Steven M. Clouse WRC Digester Mixing and System Enhancements Phase 3
Solicitation No.: CO-00455
Job No.: 20-6501

ADDENDUM No. 3
Date: February 15, 2022

RESPONSES TO QUESTIONS

CHANGES TO THE PLANS

01M18

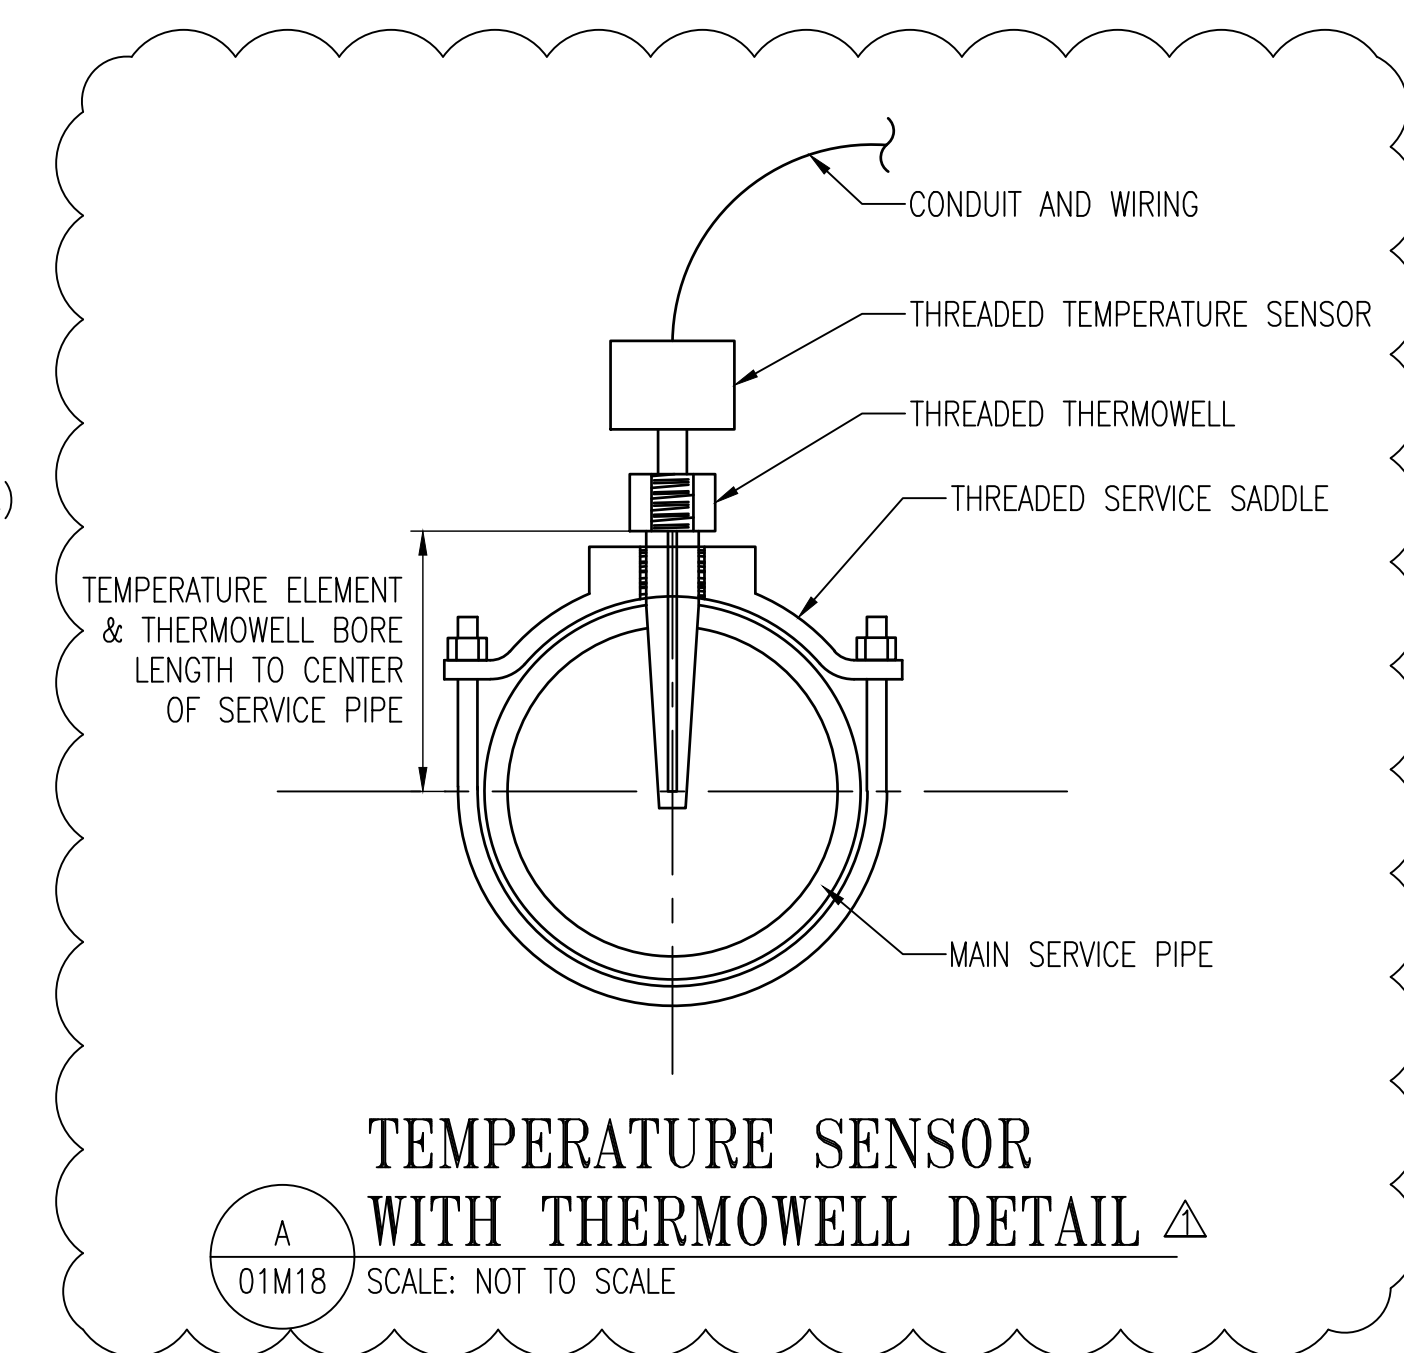
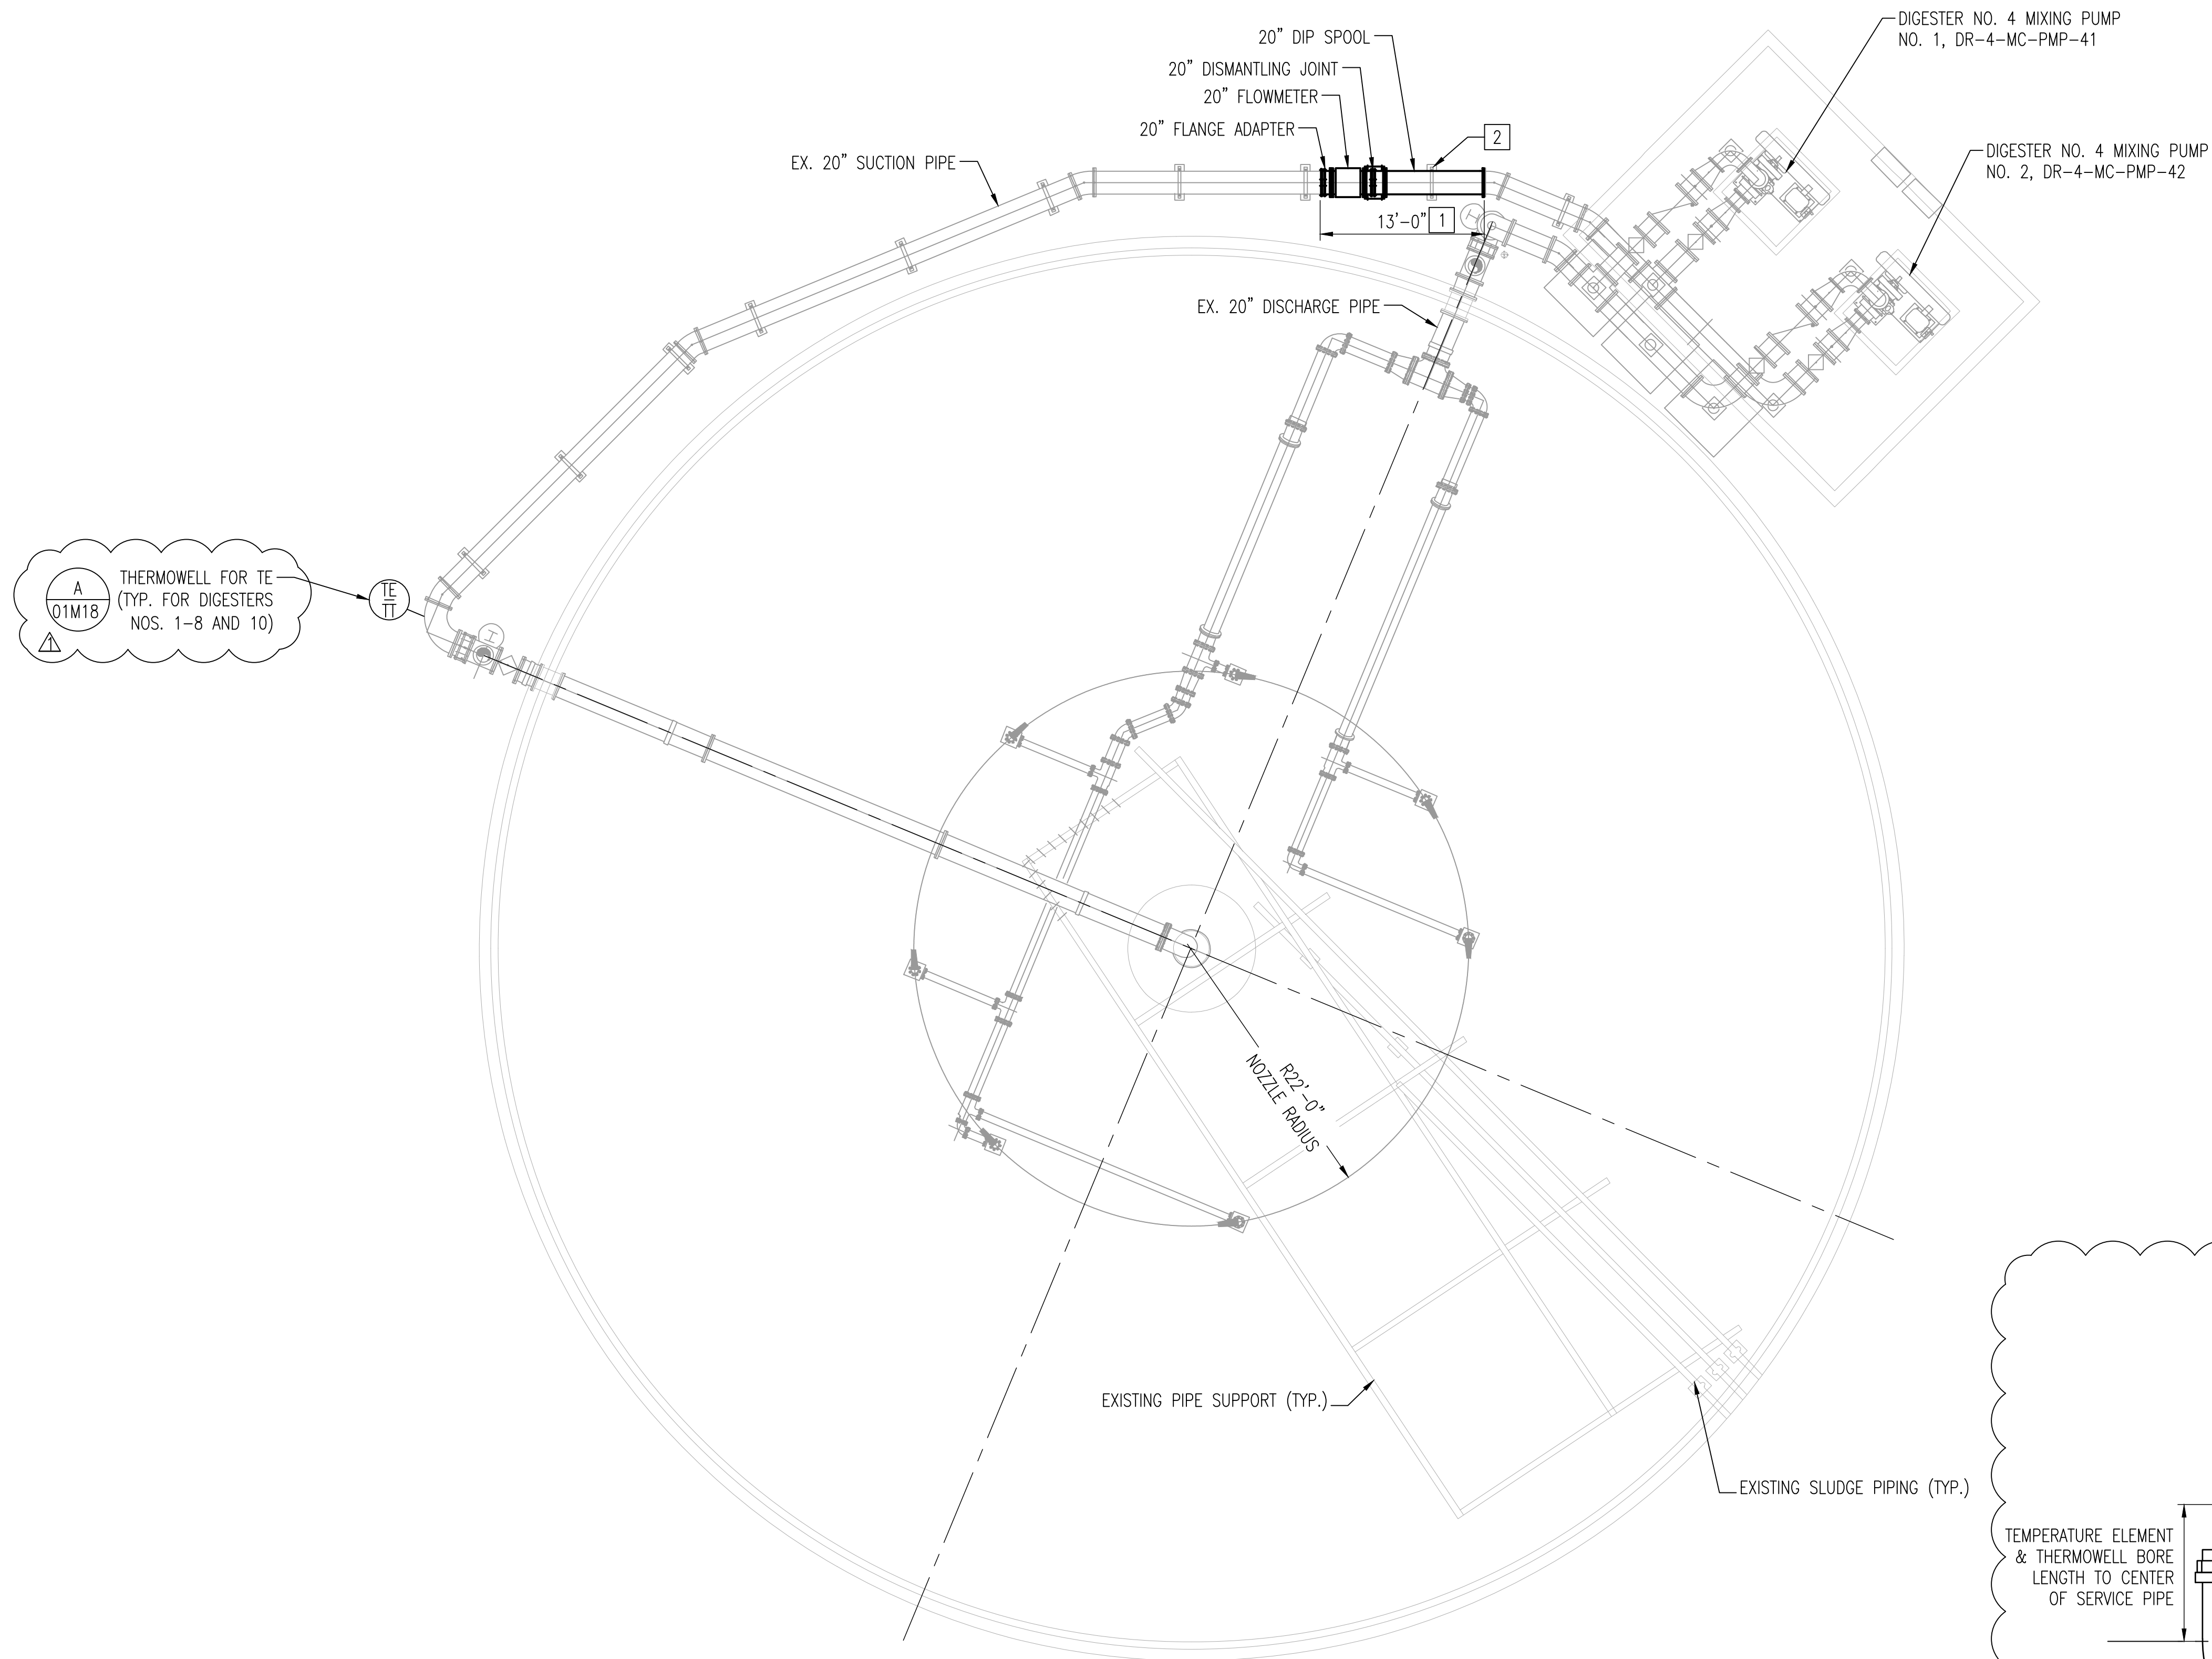
Response: Megaflanges shall not be allowed on any piping systems in this project.
3. Question: DWG 01M18 indicates a new thermowell at the existing sludge mixing pump suction line. Several other dwg's also show new thermowells on new & existing pipe. However, we are unable to find a detail for the requirements on how these are to be installed on the existing DI pipe. Are there existing taps? If not, should a saddle be used? Will detail be issued?

Response: Taps are not existing. Contractor shall tap and install a threaded service saddle on the top side of the pipe. A threaded thermowell with sufficient length to reach the center of the piping shall be attached to the service saddle. Refer to CHANGES TO THE PLANS section of this addendum, bullet 26.
4. Question: Spec 15060.2.1.5 calls for exposed exterior bolts/nuts to be stainless steel, whereas spec 15062.2.2.C.2 calls for mechanical galvanized. Which is correct?

BOILER FACILITY DEMOLITION PLAN
 (1 OF 2)
 DRAWING NO.
02MD01
 SCALE: 1/4" = 1'-0"
 DATE: NOV 2021 SHEET 61 OF 231
 DES: JG DRAWN: RL CHECK: JG

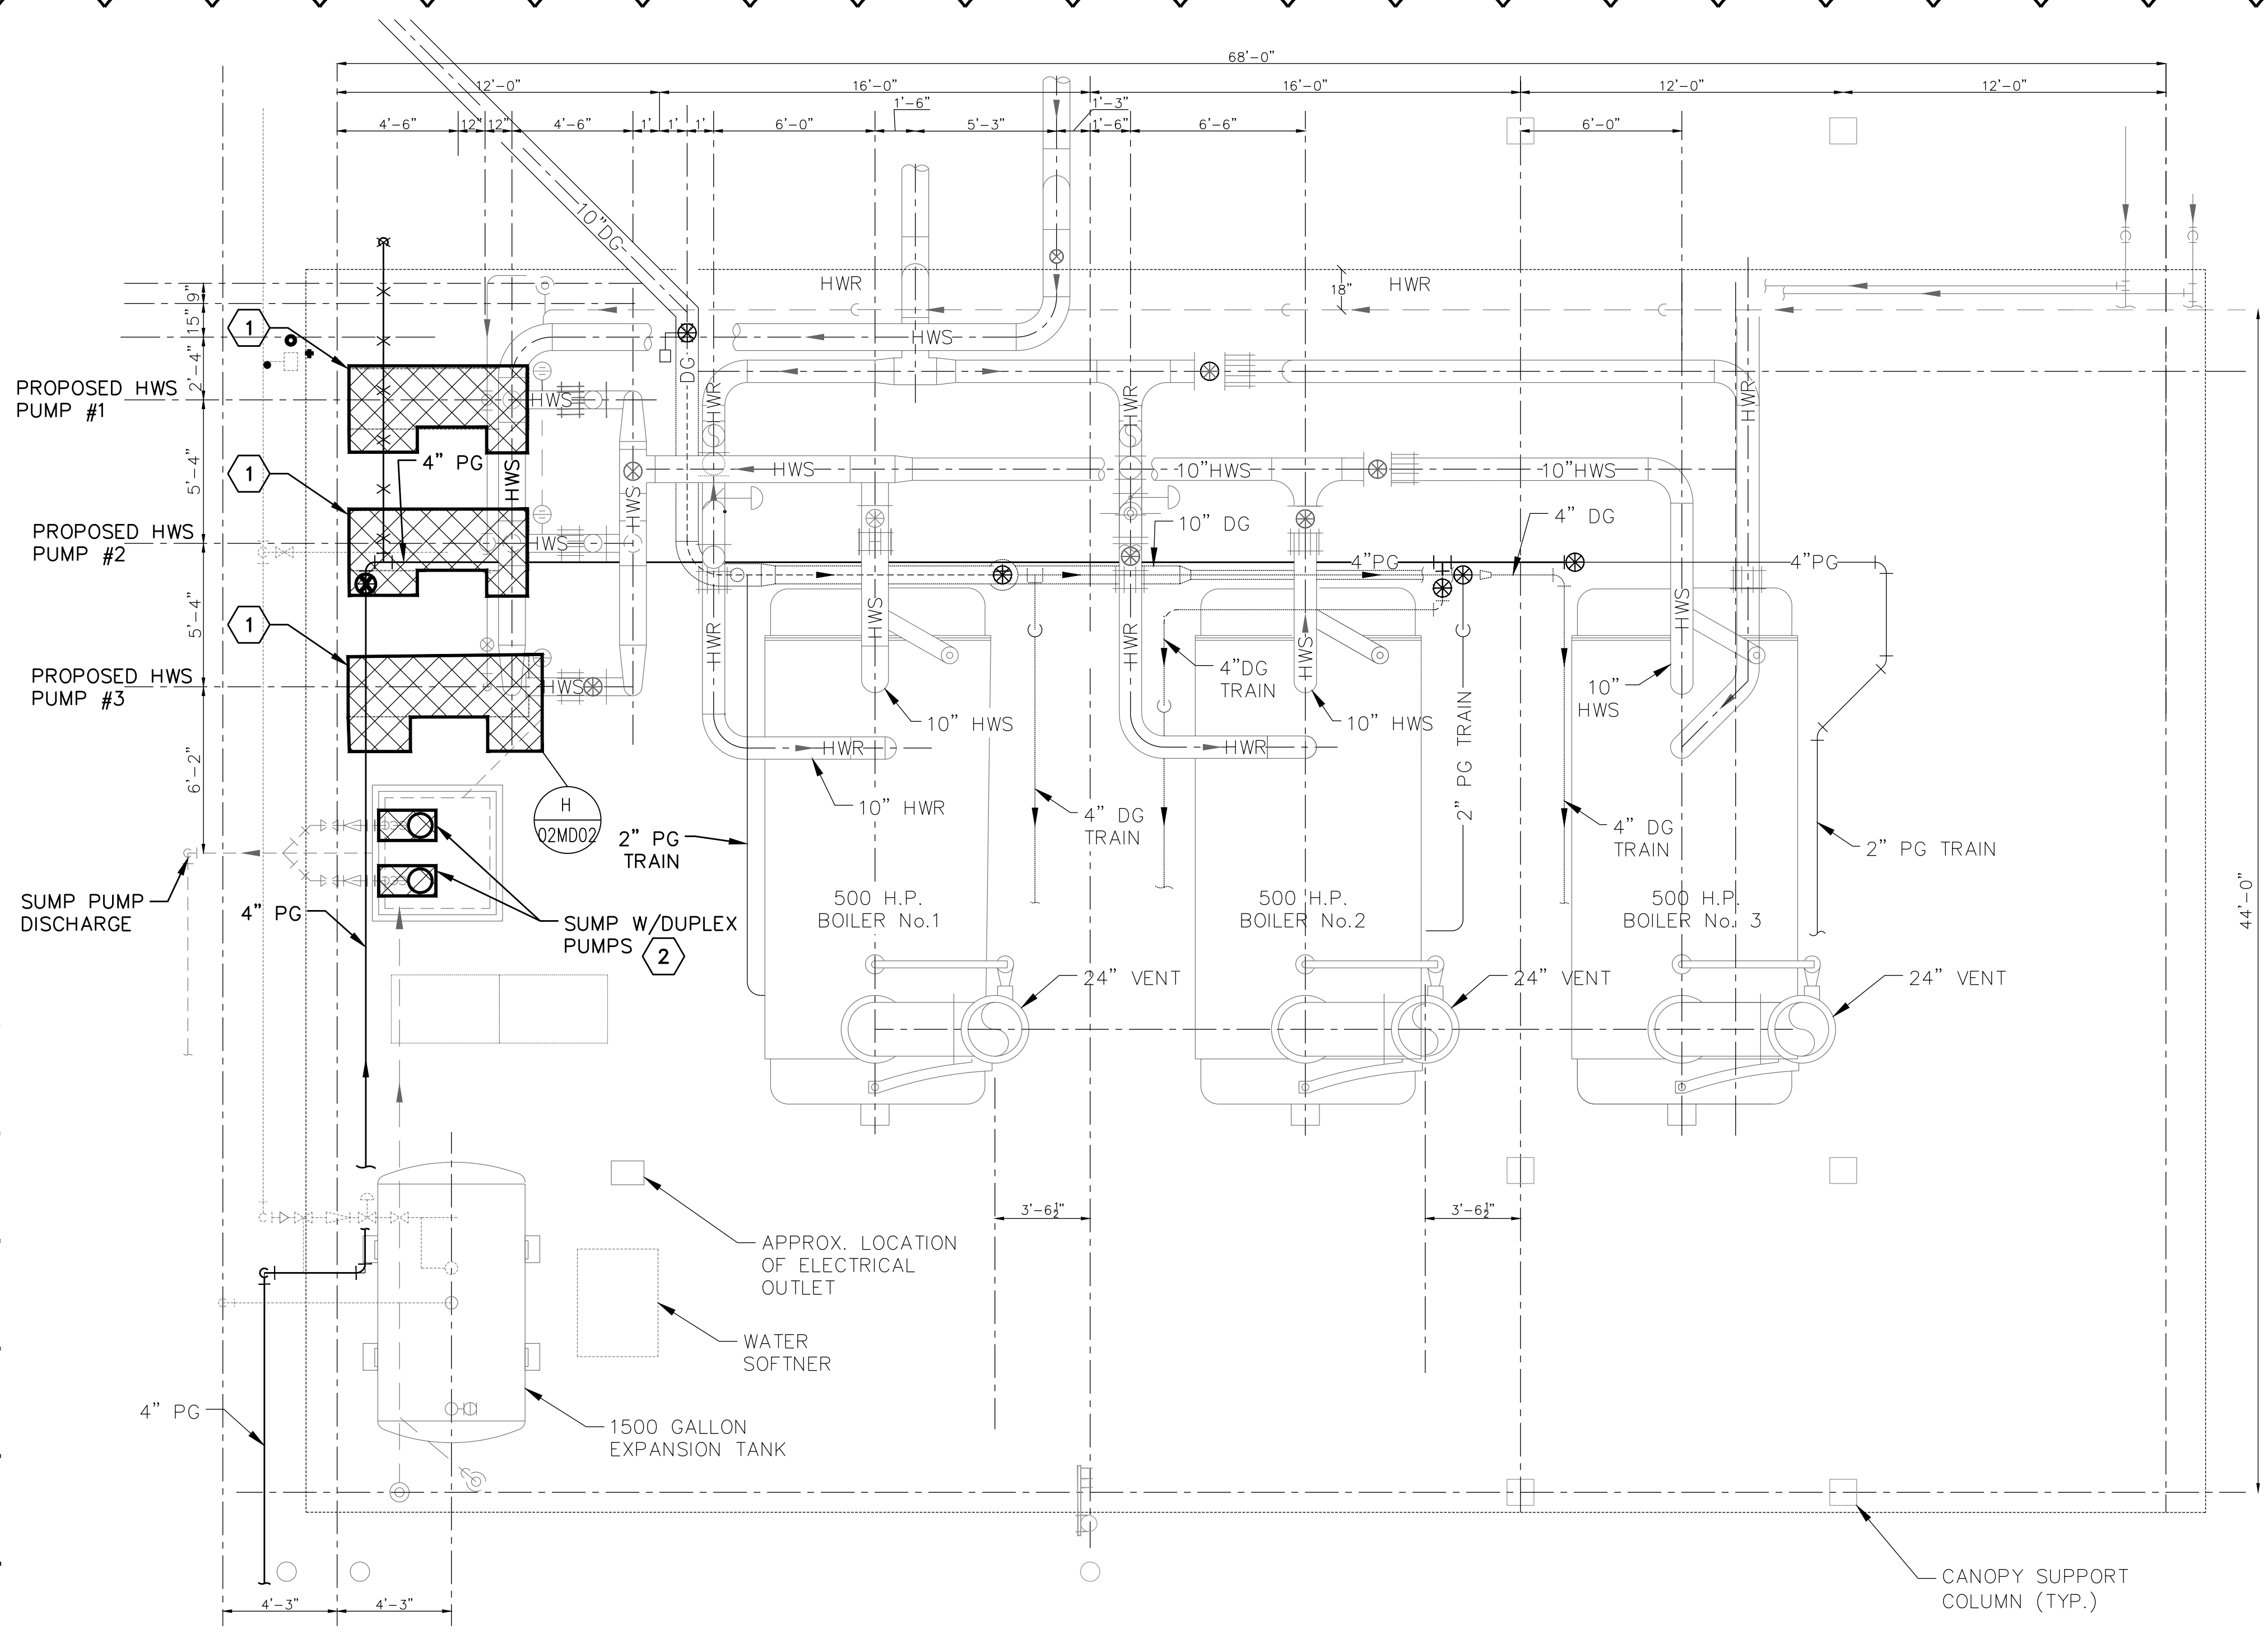
- 20.** Question: DWG 02M02 key note 8 references sheet 02ed01 for "pump and valve replace replacement plans". however, nothing on sheet 02ED01 shows anything about valve replacement. What work is required at these hws pumps/piping?

Response: *All valves in the boiler area are manual. The Key Note 8 is to coordinate between Mechanical and Electrical for the HWS pump replacement. The conduit and wire described on 02ED01 is to not to interfere with the HWS pump or valve operation and maintenance. Work at the HWS pumps shall include pump replacement, replacement of three (3) suction and three (3) discharge isolation valves and three (3) discharge check valves. Refer to I 02MD01 for existing pumps and valves to be replaced.*
